16 March 2026

Objection to SSD 975288708 – Mixed Use Development 160 Oxford Street, 142-148, 13 Gibbs Street and 6 Shadforth Street, Paddington

London Plane Trees T2-T5 in winter (Appendix 1 - Tree Data Schedule)

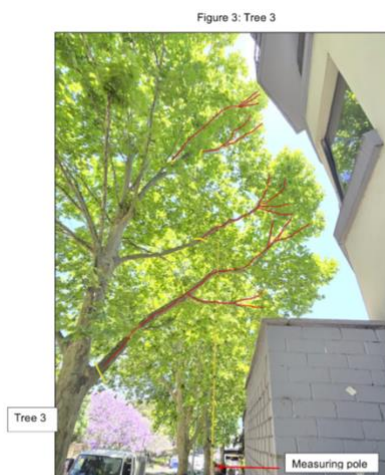
These deciduous trees will, however, lose their leaves in winter and provide little to no visual screening during the winter months. The true perception of the building from the public domain and adjoining properties in the winter time will be very different from the images provided.

This is a critical omission and a proper visual impact assessment must show summer and winter views - with and without foliage. By relying solely on the summer imagery, the unacceptable impacts are significantly understated.

The Tree Schedule in Appendix 1 of the AIS (extracted below) provides photographs of the street trees in winter - providing a very different perspective to the lush green canopy contained in the VIA imagery.

The Proposal should be assessed without assuming full and permanent tree screening. In addition, further analysis and data should be obtained to assess the likelihood that the trees can be maintained at their current size and form over the life of the development. Data should also be obtained from Council to obtain a recorded history of the trees, their ongoing maintenance and estimated lifespan.

Vehicles parking on Glenmore Rd footpath

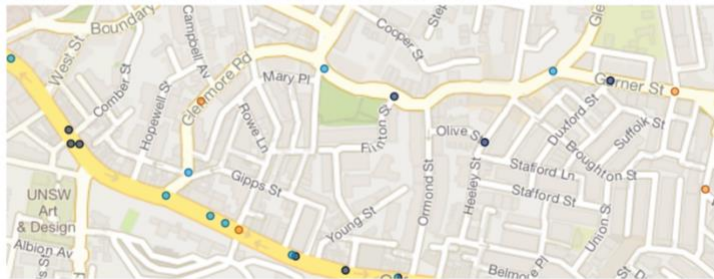
In addition, Glenmore Road is subject to a load limit for heavy vehicles of 3 tonnes and above. It is also a 'high pedestrian activity' zone and signposted accordingly. Parking has been removed from some areas of Glenmore Road to allow for the safe passage of vehicles. Cars regularly park on the footpath along Glenmore Road to avoid being side swiped or sustaining damage to side mirrors.

Figure 3A Heavy Vehicle Route Map

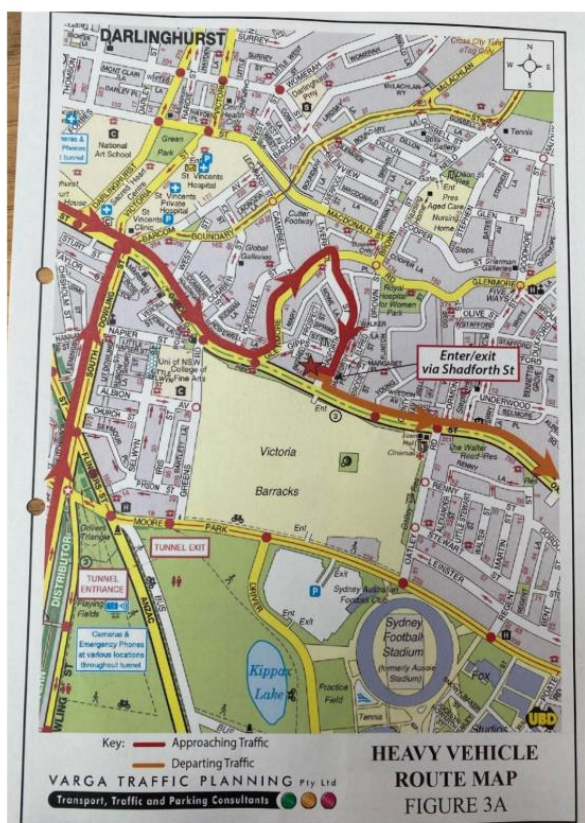
The Proponent’s Heavy Vehicle Route Map, however, directs heavy vehicles along Glenmore Rd, via Liverpool St and onto the intersection of Shadforth and Gipps Street. This is totally misconceived and unacceptable.

A revised CTMP is necessary to ensure that construction traffic and parking impacts are genuinely mitigated and are not unfairly imposed on local residents or the business community.

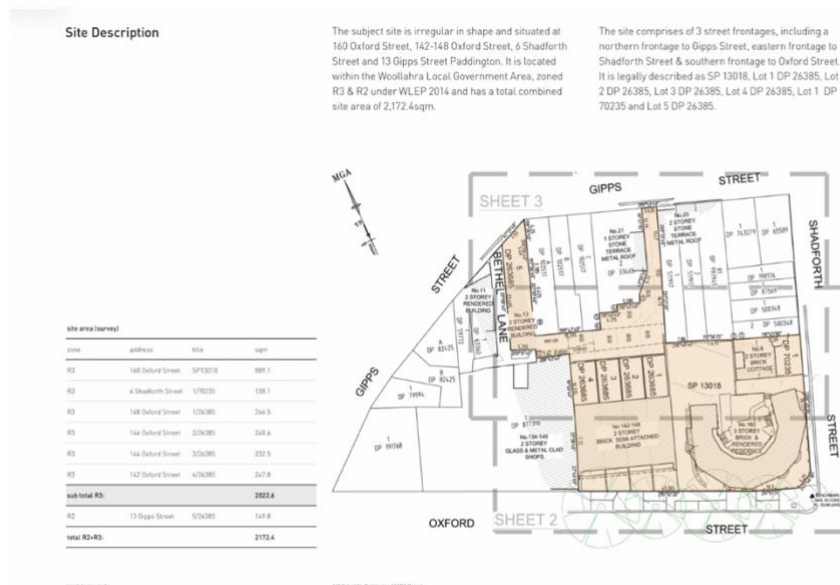
Based on my reading of the current plans, pedestrian access to the Site is via Bethel Lane. As I understand it, Bethel Lane:

The ownership status of Bethel Lane is uncertain. However, what appears to be reasonably clear from the Proposal is that the Proponent has not explained or asserted any right upon which there is a basis to include Bethel Lane for pedestrian access (or otherwise) to the Site.

Given that Bethel Lane appears to be critical to the Proposal, I request that the SEARs be amended to require the Proponent to demonstrate what rights (if any) the Proponent has to permit pedestrian access through Bethel Lane.
